Subject: **CORRECTING AUDIO JACK DEFORMATION**

Model: **PVM-8040/8041Q/8044Q**

Serial No: **2,001,801 AND HIGHER (PVM-8040)**  
**2,001,501 AND HIGHER (PVM-8041Q)**  
**2,000,901 AND HIGHER (PVM-8044Q)**

**Figure 1**

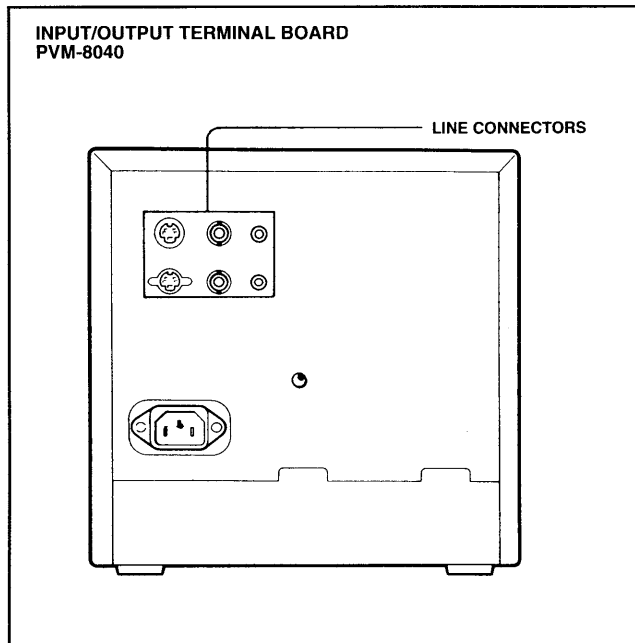
The insulating material for the audio jack on the Input-Output Terminal board may have become slightly deformed by the heat generated during production. In extreme cases, it may become difficult or impossible to insert the audio pin into the audio jack. To correct this problem, new Input-Output Terminal boards for line A and line B connectors are now available. (See Figures 1 and 2.) The new part numbers are as follows.

- PVM-8040  
 Input-Output Terminal Board  
 1-537-411-11
- PVM-8041Q/8044Q  
 Input-Output Terminal Board (Line A)  
 1-537-410-11

Input-Output Terminal Board (Line B)  
 1-537-408-11
